ITEM: 6.12	COMMITTEE OF ADJUSTMENT REPORT SUMMARY MINOR VARIANCE APPLICATION FILE NUMBER A326/22 105 VAUGHAN BLVD, THORNHILL
-------------------	--

**COMMITTEE OF ADJUSTMENT REPORT
MINOR VARIANCE APPLICATION
A326/22
105 VAUGHAN BLVD, THORNHILL**

ITEM NUMBER: 6.12	CITY WARD #: 5
APPLICANT:	Omri & Ira Dvash
AGENT:	Annette Martinez
PROPERTY:	105 Vaughan Blvd, Thornhill
ZONING DESIGNATION:	See Below
VAUGHAN OFFICIAL PLAN (2010) DESIGNATION:	Vaughan Official Plan 2010 ('VOP 2010'): "Low-Rise Residential"
RELATED DEVELOPMENT APPLICATIONS:	None
PURPOSE OF APPLICATION:	Relief from the Zoning By-law is being requested to permit an addition to the existing dwelling (addition to be constructed at rear of existing dwelling and above garage) as well as located of central air conditioning unit.

PROP. SITE PLAN

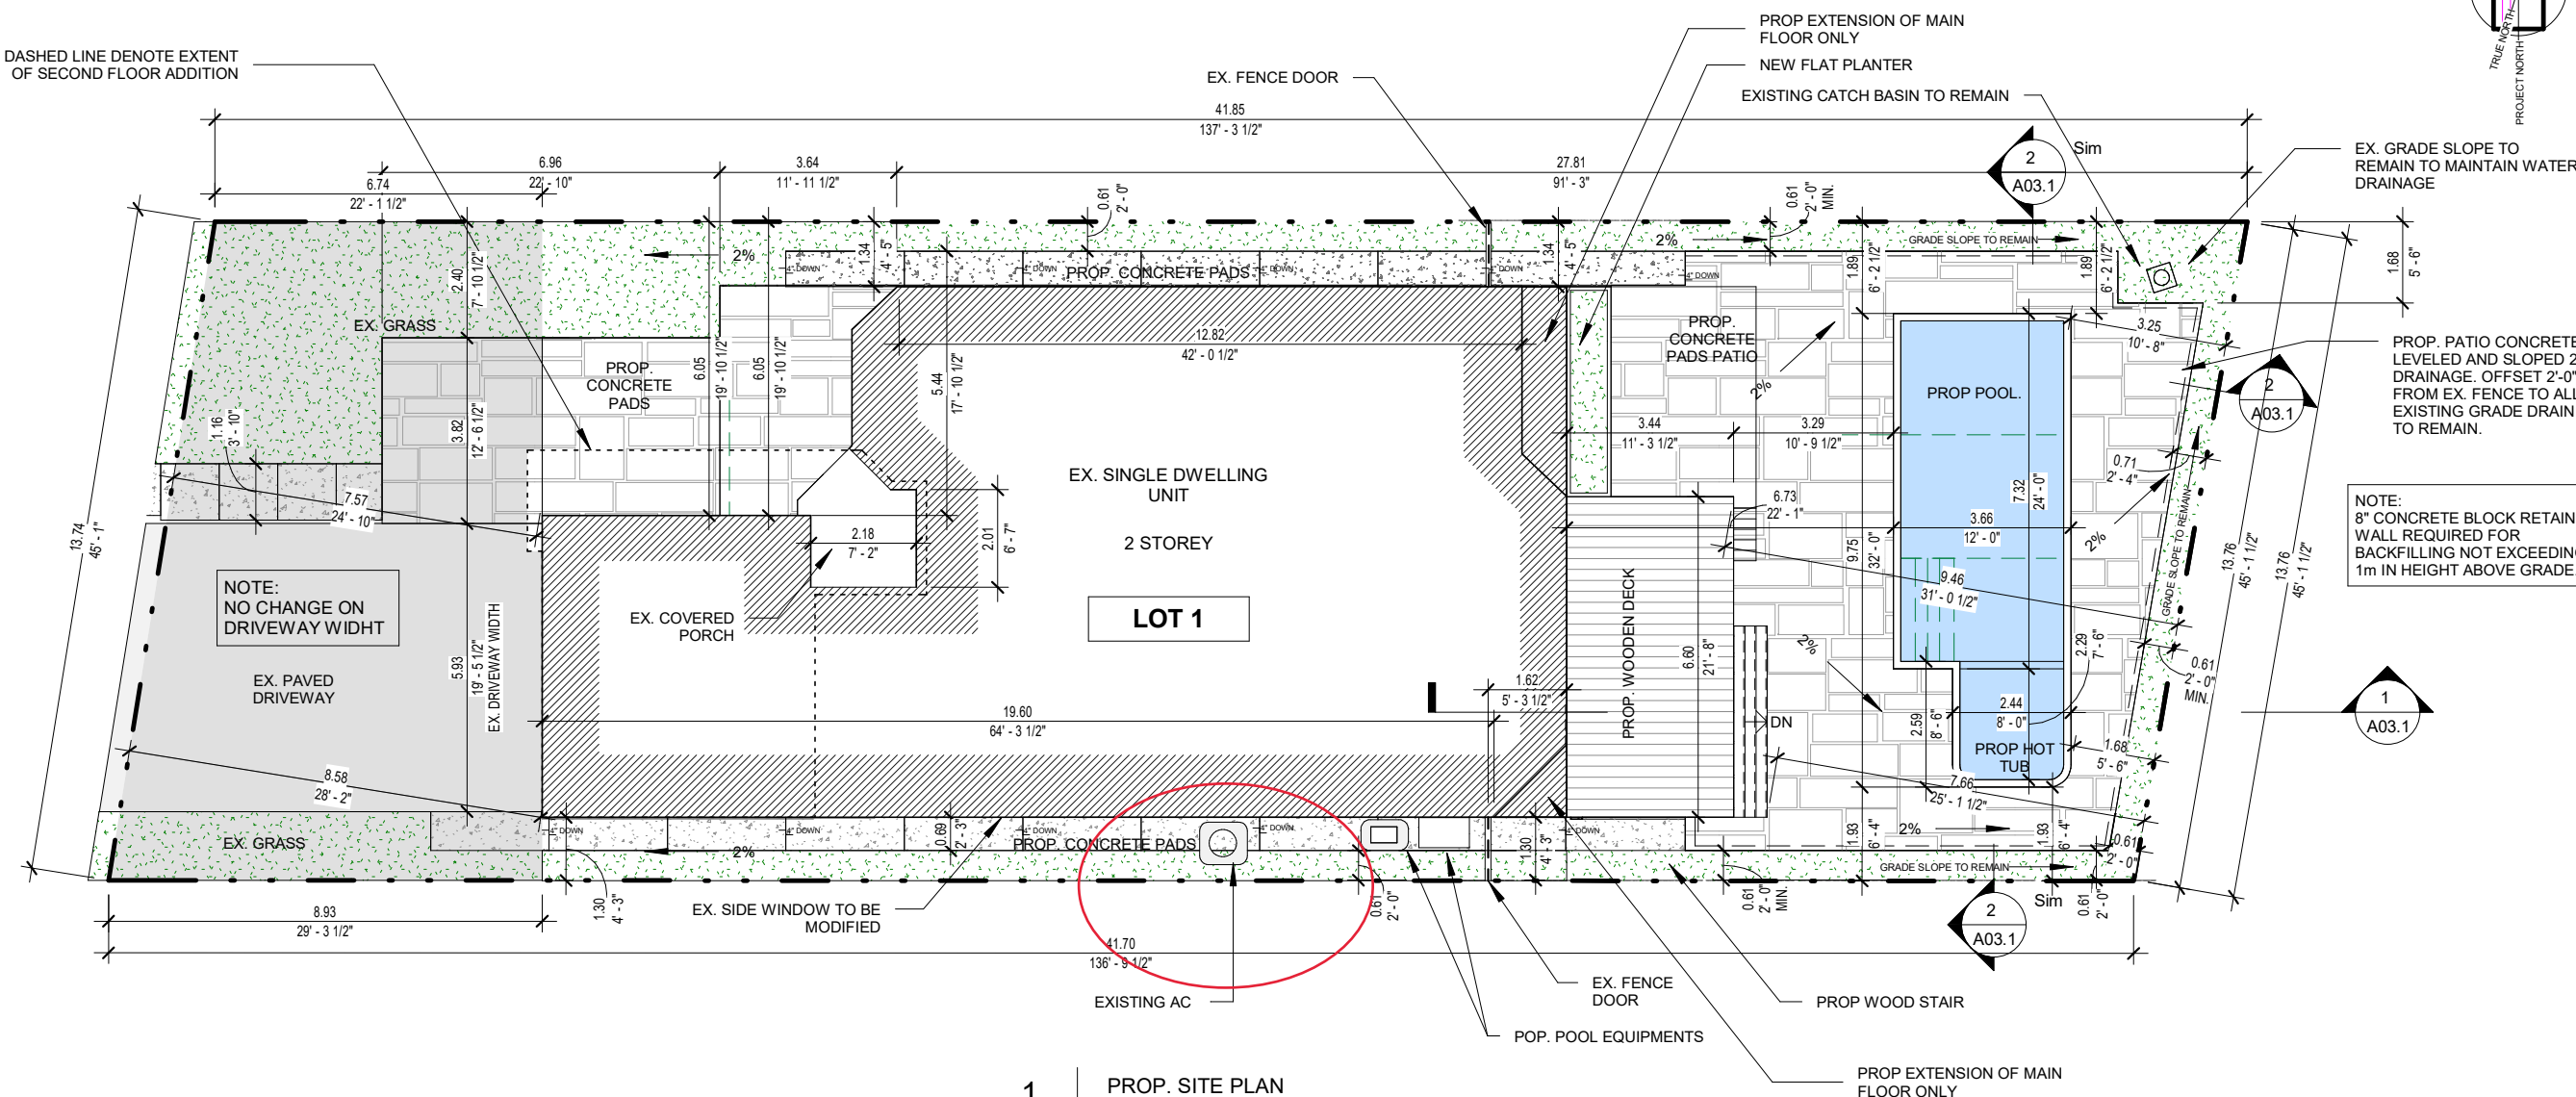
#	Zoning By-law 01-2021	Variance requested
1	A maximum lot coverage of 30% is permitted. [14.386]	To permit a maximum lot coverage of 35.5%
2	Air Conditioner (central) is permitted to encroach into the minimum required interior side yard 0.6 metres. [Section 4.13]	To permit an Air Conditioner (central) to encroach into the minimum required interior side yard 0.9 metres
